United States Patent and Trademark Office

| APPLICATION NO. | FILING DATE | FIRST NAMED INVENTOR | ATTORNEY DOCKET NO. | CONFIRMATION NO | |
|------------------------------------|-------------|----------------------|-------------------------|-----------------|--|
| 10/038,264 | 01/03/2002 | Seungbae Park | EN999048D 8328 | | |

DETAILED ACTION

JP-62-15,844

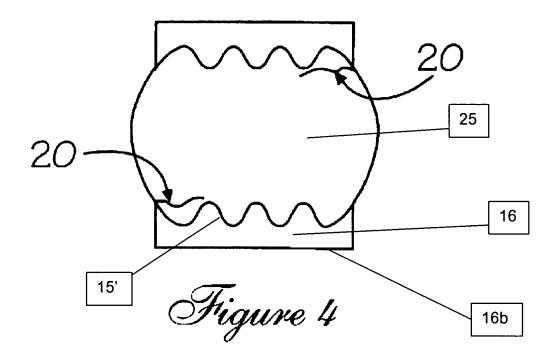
Regarding claim 9, Japanese patent '844 discloses a solder configuration comprising a pad 2 and solder 12. The pad 2 has a surface A2 characterized as non-planar and circuitous. The surface A2 is disposed within an intermetallic region A3 encompassing the surface A2 of the pad 2 and the solder 12.

The pad 2 has a surface A2 characterized as non-planar, serpentine surface. The surface A2 is disposed within an intermetallic region A3 encompassing the surface A2 of the pad 2 and the solder 12.
